TPWD Headquarters EO- ADA Evaluation

TPWD- Austin TX, HQ & Parking ADA Evaluation

Accessibility Evaluation

Inspection Date: 07/01/2020

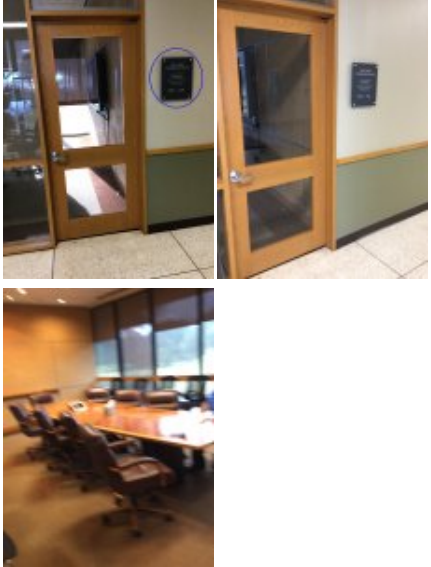
Finding Number	Area Description	Finding	As Built	Recommendation	Citation	Photos	Figure
6	First Floor, Building B100 (Public) : Restrooms and water fountains (B100) - Restroom (Men's)	The door is equipped with a door closer and returns to a closed position too quickly. Door closers and gate closers shall be adjusted so that from an open position of 90 degrees, the time required to move the door to a position of 12 degrees from the latch is 5 seconds minimum.	N/A	https://www.access-board.gov/ada/#ada-404_2_8_1	2012 TAS Section: 404.2.8.1 2010 ADAS Section: 404.2.8.1 2015 ABAAS Section: 404.2.8.1		
7	First Floor, Building B100 (Public) : Restrooms and water fountains (B100) - Restroom (Men's)	The coat hook is missing for ADA stall. Where a forward reach is unobstructed, the high forward reach shall be 48 inches maximum above the finished floor.	N/A	https://www.access-board.gov/ada/#ada-308_2_1	2012 TAS Section: 308.2.1 2010 ADAS Section: 308.2.1 2015 ABAAS Section: 308.2.1

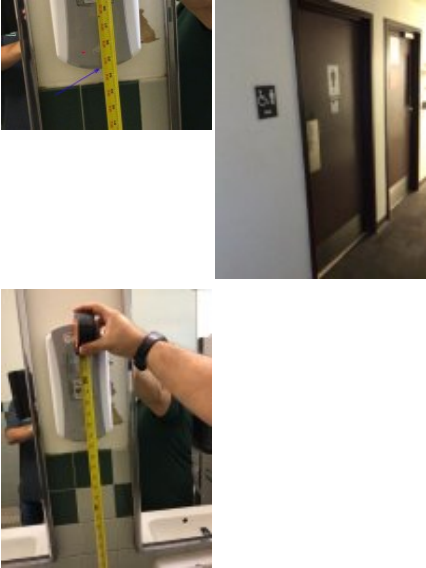
15	First Floor, Building B100 (Public) : Interior spaces (B100) - CHR Conference Room	There is no accessible route between the performance area and the assembly seating area. Where a circulation path directly connects a performance area to an assembly seating area, an accessible route shall directly connect the assembly seating area with the performance area.	There are stairs leading to presenter platform and no alternate access to platform via ramp.	Install a ramp compliant with all ADA standards outlined in 206.2.6 and ADA ramps 405 https://www.access-board.gov/ada/#ada-206_2_6 https://www.access-board.gov/ada/#ada-405_1	2012 TAS Section: 206.2.6 2010 ADAS Section: 206.2.6 2015 ABAAS Section: F206.2.6

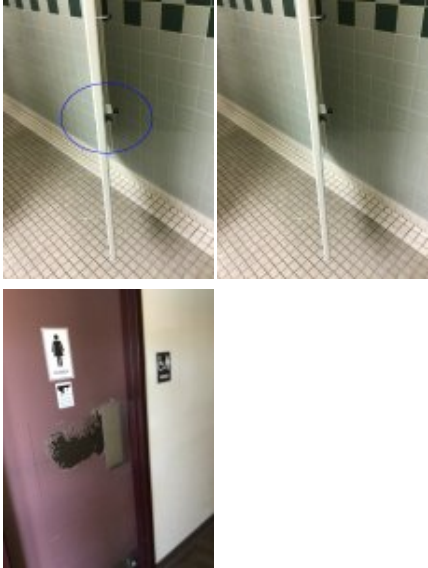
Finding Number	Area Description	Finding	As Built	Recommendation	Citation	Photos	Figure
19	Second Floor, Building B200 (STAFF): Interior spaces (B200) - Cubicle entrances	There are 2 cubicle entrances located in law enforcement area that are not compliant. The 2 cubicles located closest to elevator. **Details/locations are highlighted in blue in attached resource map. The door opening does not provide at least 32 inches between the face of the door and the opposite stop. Door openings shall provide a clear width of 32 inches minimum. Clear openings of doorways with swinging doors shall be measured between the face of the door and the stop, with the door open 90 degrees.	N/A	https://www.access-board.gov/ada/#ada-404_2_3	2012 TAS Section: 404.2.3 2010 ADAS Section: 404.2.3 2015 ABAAS Section: 404.2.3		 <p>Hinged Door</p>

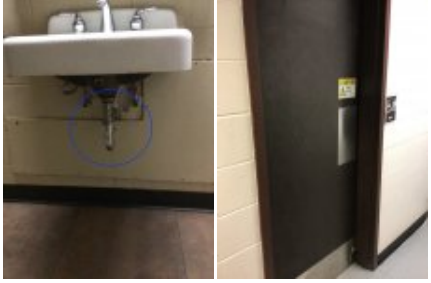
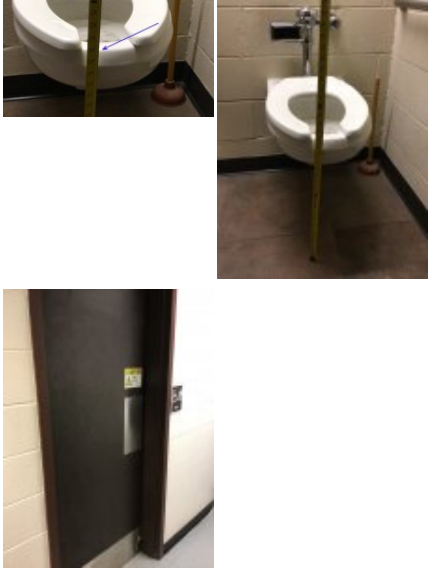
Finding Number	Area Description	Finding	As Built	Recommendation	Citation	Photos	Figure	
24	First Floor, Building D100 (Public) : Restrooms and water fountains (D100) - Women's restroom (boat)	The door exceeds the maximum allowable opening force. Interior doors shall have a maximum opening force of 5 pounds. These forces do not apply to the force required to retract latch bolts or disengage other devices that hold the door or gate in a closed position.	N/A		https://www.access-board.gov/ada/#ada-404_2_9	2012 TAS Section: 404.2.9 2010 ADAS Section: 404.2.9 2015 ABAAS Section: 404.2.9		
25	First Floor, Building D100 (Public) : Restrooms and water fountains (D100) - Women's restroom (boat)	The water closet compartment is missing a loop handle on one side or both sides of the door. Water closet compartments must be equipped with a door that has a loop or U-shaped handle on both sides of the door immediately below the latch. The latch must be flip-over style, sliding or other hardware not requiring the user to grasp or twist.	N/A		https://www.access-board.gov/ada/#ada-604_8_1_2	2012 TAS Section: 604.8.1.2 2010 ADAS Section: 604.8.1.2 2015 ABAAS Section: 604.8.1.2

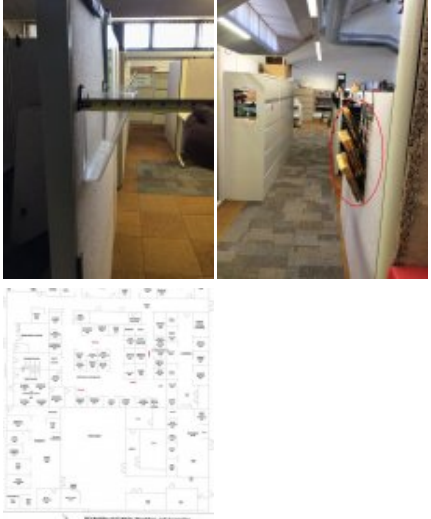
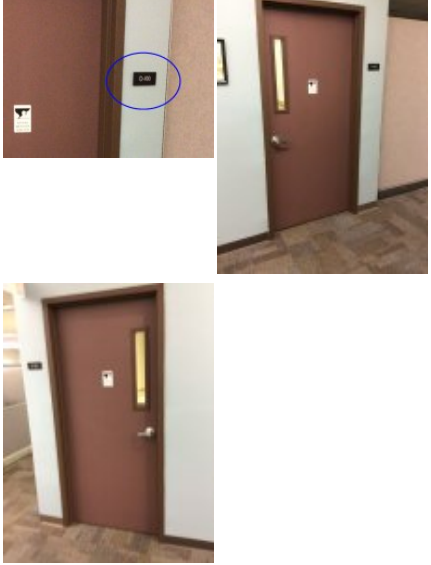
Finding Number	Area Description	Finding	As Built	Recommendation	Citation	Photos	Figure
41	First Floor, Building D100 (STAFF): Interior spaces (D100) - Women's restroom (fleet)	The toilet seat is not located within the range allowed off the floor. **Women's toilet height 21 inches The height of accessible water closets shall be a minimum of 17 inches and a maximum of 19 inches measured to the top of the toilet seat. The seat itself shall be a maximum of 2 inch high.	exceeds 19"	https://www.access-board.gov/ada/#ada-604_4	2012 TAS Section: 604.4 2010 ADAS Section: 604.4 2015 ABAAS Section: 604.4		
42	First Floor, Building D100 (STAFF): Interior spaces (D100) - Women's restroom (fleet)	Stall accessories (i.e. toilet paper, seat covers) is mounted too close to top of grab bar, minimizing the gripping surface. Adjacent elements shall be positioned to provide unobstructed use of grab bars. The space between the grab bar and projecting objects above shall be 12 inches minimum.	N/A	https://www.access-board.gov/ada/#ada-609_3	2012 TAS Section: 609.3 2010 ADAS Section: 609.3 2015 ABAAS Section: 609.3

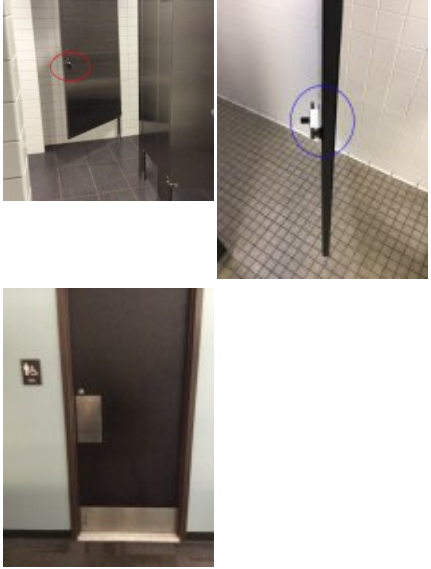
Finding Number	Area Description	Finding	As Built	Recommendation	Citation	Photos	Figure
51	First Floor, Building D100 (STAFF): Interior spaces (D100) - Conference Room D140 (fleet)	The light switch is positioned too high for either a side or front approach. Where a clear floor or ground space allows a parallel approach to an element and the side reach is unobstructed, the high side reach shall be 48 inches maximum and the low side reach shall be 15 inches minimum above the finish floor or ground. Where a forward reach is unobstructed, the high forward reach shall be 48 inches maximum and the low forward reach shall be 15 inches minimum above the finish floor or ground.	over 48"		https://www.access-board.gov/ada/#ada-308_1 2012 TAS Section: 308.1 2010 ADAS Section: 308.1 2015 ABAAS Section: 308.1		
52	First Floor, Building D100 (STAFF): Interior spaces (D100) - Conference Room D140 (fleet)	The room identification sign is noncompliant. Wall signs identifying permanent rooms and spaces of a building shall be in a horizontal format and the characters raised 1/32 inch minimum and shall be sans serif uppercase characters a minimum of 5/8 inch and a maximum of 2 inches high. Characters and their background shall have a non-glare finish. Characters shall contrast with their background with either light characters on a dark background or dark characters on a light background. Signs with raised characters or Braille shall be located 48 inches minimum above the finish floor or ground surface, measured from the baseline of the lowest tactile character and 60 inches maximum above the finish floor or ground surface, measured from the baseline of the highest tactile character.	Signs that identify a room, space or area are required to have raised characters and Braille. This requirement includes both public access areas as well as all employee areas. wall sign is not compliant Need photo verification	Wall sign designation https://www.access-board.gov/ada/#ada-216_2 Wall signs general https://www.access-board.gov/ada/#ada-703_1	2012 TAS Section: 216.2, 703.1 2010 ADAS Section: 216.2, 703.1 2015 ABAAS Section: F216.2, 703.1

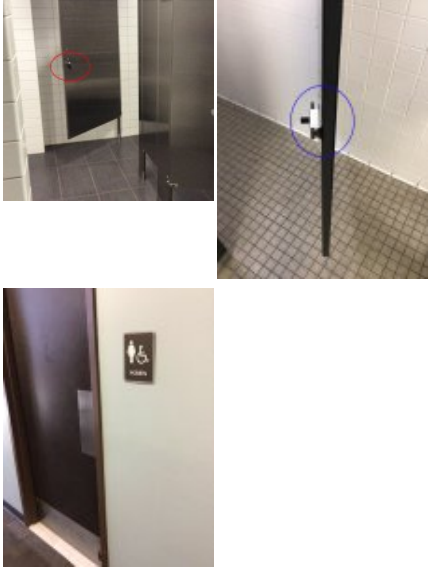
54	First Floor, Building A100 (STAFF): Building Entrance and Lobby (A100) - Elevators	At least one accessible route (i.e. elevator, ramp or platform lift) shall connect each story and mezzanine in multistory buildings and facilities. The elevator exemption note below does not apply to Title II government facilities and entities. Title II facilities must make their programs accessible. If vertical access cannot be achieved, then the program must be relocated, removed or made accessible. The following buildings and facilities do not require vertical access: In private buildings or facilities that are less than three stories or that have less than 3000 square feet per story, an accessible route shall not be required to connect stories provided that the building or facility is not a shopping center, a shopping mall, the professional office of a health care provider, a terminal, depot or other station used for specified public transportation, an airport passenger terminal, or another type of facility as determined by the Attorney General.	N/A	https://www.access-board.gov/ada/#ada-206_2_3	2012 TAS Section: 206.2.3 2010 ADAS Section: 206.2.3 2015 ABAAS Section: F206.2.3

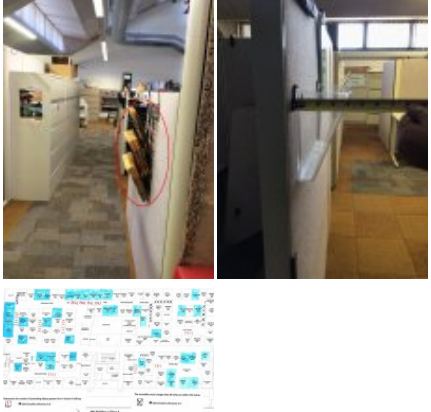
Finding Number	Area Description	Finding	As Built	Recommendation	Citation	Photos	Figure
57	First Floor, Building A100 (STAFF): Restrooms and water fountains (A100) - Men's restroom	The water closet compartment is missing a loop handle on one side or both sides of the door. Water closet compartments must be equipped with a door that has a loop or U-shaped handle on both sides of the door near the latch. The latch must be flip-over style, sliding or other hardware not requiring the user to grasp or twist.	N/A	https://www.access-board.gov/ada/#ada-604_8_1_2	2012 TAS Section: 604.8.1.2 2010 ADAS Section: 604.8.1.2 2015 ABAAS Section: 604.8.1.2		
58	First Floor, Building A100 (STAFF): Restrooms and water fountains (A100) - Men's restroom	The door exceeds the maximum allowable opening force. Interior doors shall have a maximum opening force of 5 pounds. These forces do not apply to the force required to retract latch bolts or disengage other devices that hold the door or gate in a closed position.	N/A	https://www.access-board.gov/ada/#ada-404_2_9	2012 TAS Section: 404.2.9 2010 ADAS Section: 404.2.9 2015 ABAAS Section: 404.2.9

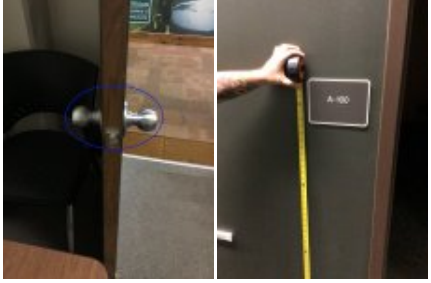
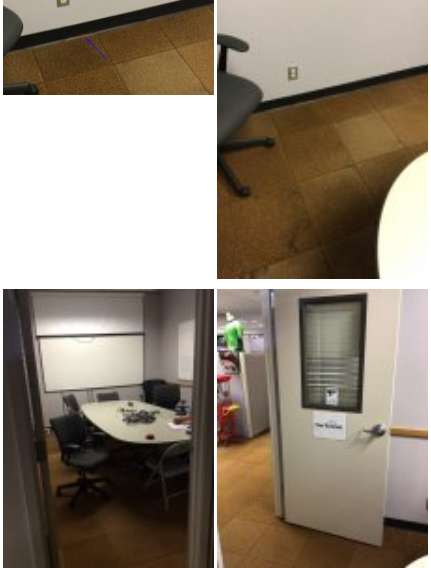
Finding Number	Area Description	Finding	As Built	Recommendation	Citation	Photos	Figure
59	First Floor, Building A100 (STAFF): Restrooms and water fountains (A100) - Women's restroom	The water closet compartment is missing a loop handle on one side or both sides of the door. Water closet compartments must be equipped with a door that has a loop or U-shaped handle on both sides of the door near the latch. The latch must be flip-over style, sliding or other hardware not requiring the user to grasp or twist.	missing one side	https://www.access-board.gov/ada/#ada-604_8_1_2	2012 TAS Section: 604.8.1.2 2010 ADAS Section: 604.8.1.2 2015 ABAAS Section: 604.8.1.2		
60	First Floor, Building A100 (STAFF): Restrooms and water fountains (A100) - Women's restroom	The door exceeds the maximum allowable opening force. Interior doors shall have a maximum opening force of 5 pounds. These forces do not apply to the force required to retract latch bolts or disengage other devices that hold the door or gate in a closed position.	N/A	https://www.access-board.gov/ada/#ada-404_2_9	2012 TAS Section: 404.2.9 2010 ADAS Section: 404.2.9 2015 ABAAS Section: 404.2.9

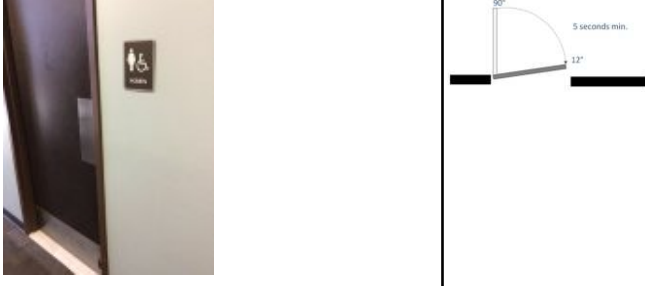
Finding Number	Area Description	Finding	As Built	Recommendation	Citation	Photos	Figure
66	First Floor, Building A100 (STAFF): Interior spaces (A100) - Conference Room A100	The door/gate operating hardware is not accessible. ** Both entry doors for A100 Hand-activated door/gate opening hardware, handles, pulls, latches, locks, and other operating devices on accessible doors shall have a shape that is easy to grasp with one hand and does not require tight grasping, pinching or twisting of the wrist to operate. Hardware shall be 34 inches minimum and 48 inches maximum above the finish floor or ground.	N/A		https://www.access-board.gov/ada/#ada-404_2_7 2012 TAS Section: 404.2.7 2010 ADAS Section: 404.2.7 2015 ABAAS Section: 404.2.7		
67	First Floor, Building A100 (STAFF): Interior spaces (A100) - Summit Conference Room	Carpet is not securely attached Actual citation is 302.2 Carpet. Carpet or carpet tile shall be securely attached and shall have a firm cushion, pad, or backing or no cushion or pad. Carpet or carpet tile shall have a level loop, textured loop, level cut pile, or level cut/uncut pile texture. Pile height shall be ½ inch (13 mm) maximum. Exposed edges of carpet shall be fastened to floor surfaces and shall have trim on the entire length of the exposed edge. Carpet edge trim shall comply with 303.	N/A	Rubber inserts can be installed to bring carpet flush to wall to eliminate tripping hazard. https://www.access-board.gov/ada/#ada-302_1	2012 TAS Section: 302.1 2010 ADAS Section: 302.1, 302 2015 ABAAS Section: 302.1

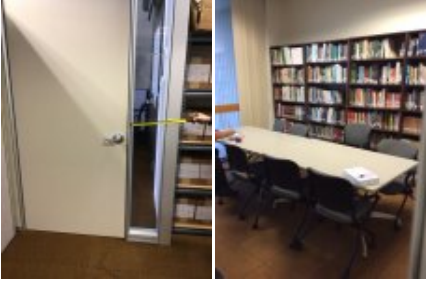
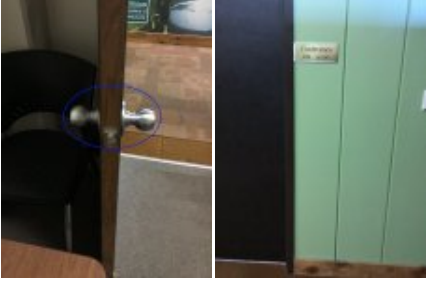
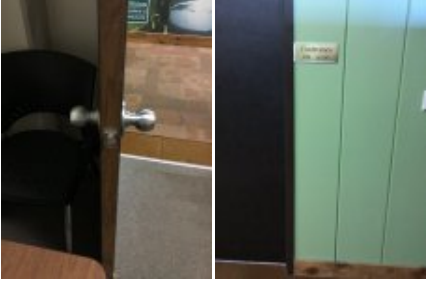
Finding Number	Area Description	Finding	As Built	Recommendation	Citation	Photos	Figure
72	Second Floor, Building A200 (STAFF): Restrooms and water fountains (A200) - Women's restroom	The threshold has a vertical change greater than 1/4 inch. The threshold at a doorway shall be no higher than 1/2 inch. Changes in level between 1/4 inch and 1/2 inch must be beveled at 1:2 or less. The maximum vertical rise shall be 1/4 inch.	threshold exceeds 1/2" max		https://www.access-board.gov/ada/#ada-404_2_5	2012 TAS Section: 404.2.5 2010 ADAS Section: 404.2.5 2015 ABAAS Section: 404.2.5	
73	Second Floor, Building A200 (STAFF): Restrooms and water fountains (A200) - Women's restroom	The door exceeds the maximum allowable opening force. Interior doors shall have a maximum opening force of 5 pounds. These forces do not apply to the force required to retract latch bolts or disengage other devices that hold the door or gate in a closed position.	N/A		https://www.access-board.gov/ada/#ada-404_2_9	2012 TAS Section: 404.2.9 2010 ADAS Section: 404.2.9 2015 ABAAS Section: 404.2.9

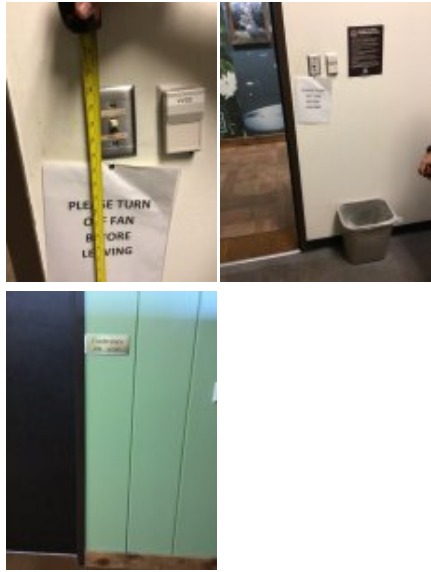
Finding Number	Area Description	Finding	As Built	Recommendation	Citation	Photos	Figure
75	Second Floor, Building A200 (STAFF): Restrooms and water fountains (A200) - Women's restroom	The water closet compartment is missing a loop handle on one side or both sides of the door. Water closet compartments must be equipped with a door that has a loop or U-shaped handle on both sides of the door immediately below the latch. The latch must be flip-over style, sliding or other hardware not requiring the user to grasp or twist.	missing	https://www.access-board.gov/ada/#ada-604_8_1_2	2012 TAS Section: 604.8.1.2 2010 ADAS Section: 604.8.1.2 2015 ABAAS Section: 604.8.1.2		
76	Second Floor, Building A200 (STAFF): Restrooms and water fountains (A200) - Water Fountain	The drinking fountain is not accessible. The water fountains spread throughout A200 are not accessible due to a number of factors. ** A200 water refill stations are compliant. Drinking fountains must be on an accessible route. An accessible route of travel is 36 inches wide minimum and provides a 30 inch by 48 inch clear floor space centered on the unit that allows a forward approach to the drinking fountain. At "hi-low" type fountains, the centerline of the 30 inch by 48 inch clear floor space must be centered on the "low" fountain. Spout outlets of drinking fountains for standing persons shall be 38 inches minimum and 43 inches maximum above the finish floor or ground. All drinking fountains shall be located completely within alcoves, positioned completely between wing walls, or otherwise positioned so as not to encroach into pedestrian ways. An alcove must not be less than 32 inches in width and 18 inches in depth. Wing walls must project out from the supporting wall at least as far as the drinking fountain.	Water fountain has been removed, water refill stations are accessible	Staff can use the water refill station located in building 200. Staff can use public water fountains located in building B100 as those are ADA compliant.	2012 TAS Section: 403.5.1, 602.1 2010 ADAS Section: 403.5.1, 602.1 2015 ABAAS Section: 403.5.1, 602.1

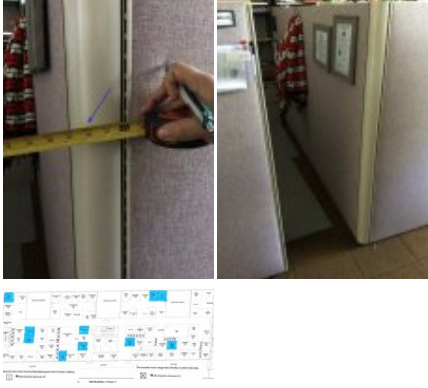
Finding Number	Area Description	Finding	As Built	Recommendation	Citation	Photos	Figure
79	Second Floor, Building A200 (STAFF): Interior spaces (A200) - Balcony Conference Room	The room identification sign is noncompliant. Multiple violations regarding sign contrast, height mount, and braille lettering. Wall signs identifying permanent rooms and spaces of a building shall be in a horizontal format and the characters raised 1/32 inch minimum and shall be sans serif uppercase characters a minimum of 5/8 inch and a maximum of 2 inches high. Characters and their background shall have a non-glare finish. Characters shall contrast with their background with either light characters on a dark background or dark characters on a light background. Signs with raised characters or Braille shall be located 48 inches minimum above the finish floor or ground surface, measured from the baseline of the lowest tactile character and 60 inches maximum above the finish floor or ground surface, measured from the baseline of the highest tactile character.	Signs that identify a room, space or area are required to have raised characters and Braille. This requirement includes both public access areas as well as all employee areas. Wall sign is not compliant, none provided	Wall sign designation https://www.access-board.gov/ada/#ada-216_2 Wall signs general https://www.access-board.gov/ada/#ada-703_1 Height Above Finish Floor or Ground https://www.access-board.gov/ada/#ada-703_4_1 Location https://www.access-board.gov/ada/#ada-703_4_2	2012 TAS Section: 216.2, 703.1 2010 ADAS Section: 216.2, 703.1 2015 ABAAS Section: F216.2, 703.1

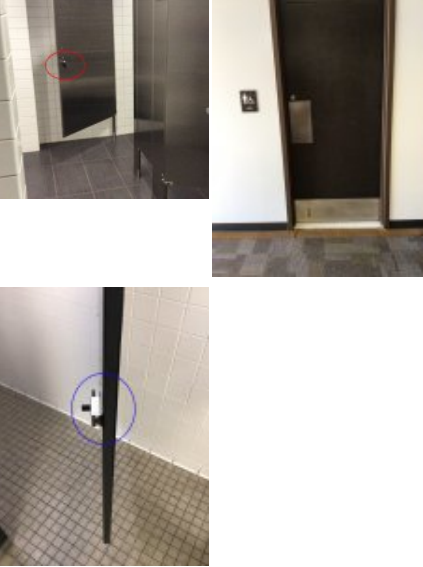
Finding Number	Area Description	Finding	As Built	Recommendation	Citation	Photos	Figure
84	Second Floor, Building A200 (STAFF): Interior spaces (A200) - Walkways	The route of travel does not provide a minimum width of 36 inches. There are 6 areas of non compliance in State Park wing and 1 area in infrastructure wing. **Details/locations are marked as (X) in attached resource map. The clear width shall be permitted to be reduced to 32 inches minimum for a length of 24 inches maximum provided that reduced width segments are separated by segments that are 48 inches long minimum and 36 inches wide minimum.	N/A	https://www.access-board.gov/ada/#ada-403_5_1	2012 TAS Section: 403.5.1 2010 ADAS Section: 403.5.1 2015 ABAAS Section: 403.5.1		
85	Second Floor, Building A200 (STAFF): Interior spaces (A200) - Walkways	The element projects more than 4 inches into the circulation path. There were a small amount of these infractions noted all located on balcony side of hallway. **Details/locations are marked with red (I) in attached resource map. Wall-mounted objects that have leading edges between 27 inches and 80 inches from the floor must not project more than 4 inches into the circulation path. Protruding objects that extend to the floor or within 27 inches of the floor are cane detectable and are therefore not hazardous. Where it is necessary or desirable to have objects protrude from the wall, a manner of cane detection must be provided.	exceed 4" max	https://www.access-board.gov/ada/#ada-307_2	2012 TAS Section: 307.2 2010 ADAS Section: 307.2 2015 ABAAS Section: 307.2		<p>4" max 4" is the max. an object may project if the bottom is greater than 27" off the floor X > 27</p>

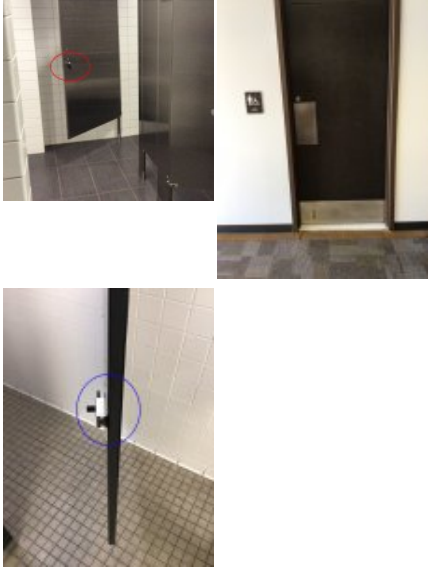
Finding Number	Area Description	Finding	As Built	Recommendation	Citation	Photos	Figure
87	First Floor, Building C100 (STAFF): Building Entrance and Lobby (C100) - Service Counter (HR - Public Element)	The counter is higher than 36 inches above the floor. A portion of the counter surface that is 30 inches long minimum and 36 inches high maximum shall be provided. Knee and toe space shall be provided under the counter. A clear floor or ground space shall be positioned for a forward approach to the counter.	Not enough space provided for parallel or front approach.	Service desks approach requirements https://www.access-board.gov/ada/#ada-904_4 Parallel approach https://www.access-board.gov/ada/#ada-904_4_1 Forward approach https://www.access-board.gov/ada/#ada-904_4_2	2012 TAS Section: 904.4.2 2010 ADAS Section: 904.4.2 2015 ABAAS Section: 904.4.2		
88	First Floor, Building C100 (STAFF): Building Entrance and Lobby (C100) - Elevators	Specifically the elevator dimensions, door operation, and no audible sound for all elevators on HQ property are non compliant. The existing passenger elevators contain several non compliant features in accordance with ASME A17.1, (Safety Code for Elevators and Escalators). The elevator car size (XX) (length & width) (XX) is are too small, door operation, door size, door protective and reopening devices are noncompliant, hall & car calls are incorrect and/or missing, the hall lantern and door jamb markings are missing and/or incorrect. An audible signal shall sound once for the "up" direction and twice for the "down" direction or shall have verbal annunciators that say "up" or "down." Contact the elevator contractor and/or vendor to ensure compliance with ASME A17.1.	N/A	Currently there is not a way a person with physical disability can independently access and utilize elevator. Accommodations would need to be made by TPWD staff to assist with elevator use. https://www.access-board.gov/ada/#ada-407_1	2012 TAS Section: 407.1 2010 ADAS Section: 407.1 2015 ABAAS Section: 407.1

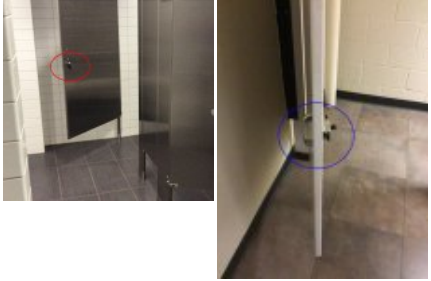
Finding Number	Area Description	Finding	As Built	Recommendation	Citation	Photos	Figure
89	First Floor, Building C100 (STAFF): Building Entrance and Lobby (C100) - Elevators	At least one accessible route (i.e. elevator, ramp or platform lift) shall connect each story and mezzanine in multistory buildings and facilities. The elevator exemption note below does not apply to Title II government facilities and entities. Title II facilities must make their programs accessible. If vertical access cannot be achieved, then the program must be relocated, removed or made accessible. The following buildings and facilities do not require vertical access: In private buildings or facilities that are less than three stories or that have less than 3000 square feet per story, an accessible route shall not be required to connect stories provided that the building or facility is not a shopping center, a shopping mall, the professional office of a health care provider, a terminal, depot or other station used for specified public transportation, an airport passenger terminal, or another type of facility as determined by the Attorney General.	N/A	https://www.access-board.gov/ada/#ada-206_2_3	2012 TAS Section: 206.2.3 2010 ADAS Section: 206.2.3 2015 ABAAS Section: F206.2.3

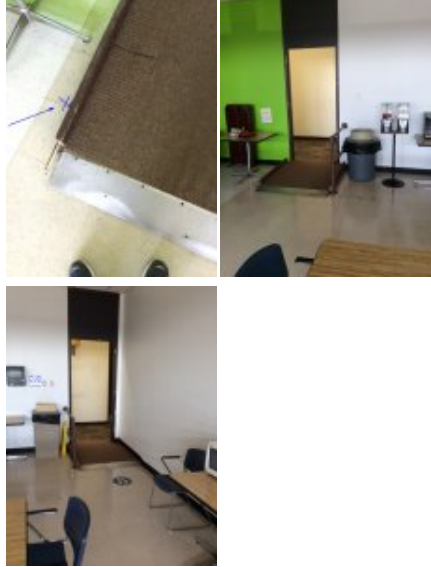
Finding Number	Area Description	Finding	As Built	Recommendation	Citation	Photos	Figure
93	First Floor, Building C100 (STAFF): Restrooms and water fountains (C100) - Men's restroom	The water closet compartment is missing a loop handle on one side or both sides of the door. Water closet compartments must be equipped with a door that has a loop or U-shaped handle on both sides of the door near the latch. The latch must be flip-over style, sliding or other hardware not requiring the user to grasp or twist.	missing	https://www.access-board.gov/ada/#ada-604_8_1_2	2012 TAS Section: 604.8.1.2 2010 ADAS Section: 604.8.1.2 2015 ABAAS Section: 604.8.1.2		
94	First Floor, Building C100 (STAFF): Restrooms and water fountains (C100) - Men's restroom	The door exceeds the maximum allowable opening force. Interior doors shall have a maximum opening force of 5 pounds. These forces do not apply to the force required to retract latch bolts or disengage other devices that hold the door or gate in a closed position.	exceeds 5lbs of force to operate	https://www.access-board.gov/ada/#ada-404_2_9	2012 TAS Section: 404.2.9 2010 ADAS Section: 404.2.9 2015 ABAAS Section: 404.2.9
